PREVOST

**WARRANTY
BULLETIN**

Wb11-21

DATE : MAY 2011	SECTION : 16 - Suspension
EXPIRATION: MAY 2013	
SUBJECT : FRONT AXLE LONGITUDINAL RADIUS ROD SUPPORTS - INSPECTION OF DOWEL PINS

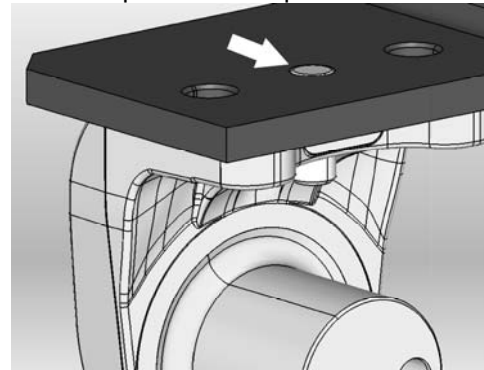
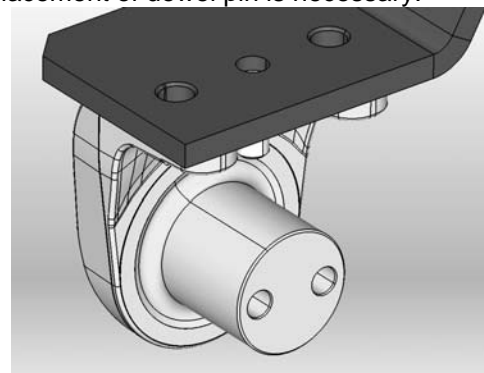
2. Check if dowel pins have moved downwards. The top of the dowel pins must be flush with the plate surface. Assure that the dowel pins are firmly holding in the hole and not loose. If the dowel pins are loose or are not flush, replace dowel pin as described in the replacement procedure.

Top of dowel pin flush with plate surface

Dowel pin moved downwards. Top of dowel pin not flush with plate surface. Removal and replacement of dowel pin is necessary.

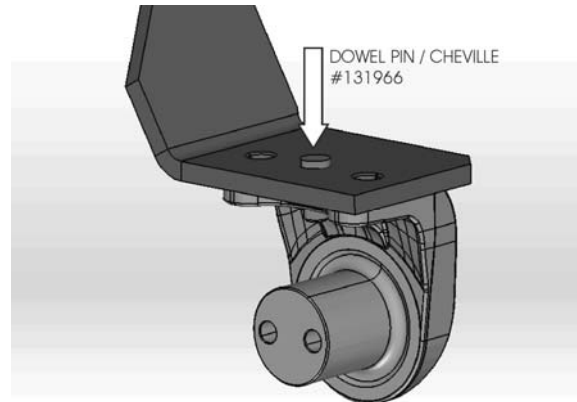
7. Remove the existing dowel pin. Clean hole.
8. On top of the support, insert the new dowel pin #131966. To ease installation, use a C clamp.

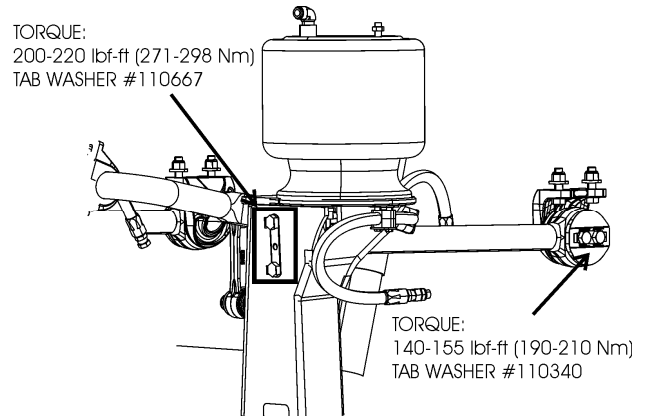
9. Reinstall the radius rod. Reinstall the alignment shim(s) between the radius rod support and the mounting surface in order to maintain proper wheel alignment. Tighten mounting bolts as specified on the image.
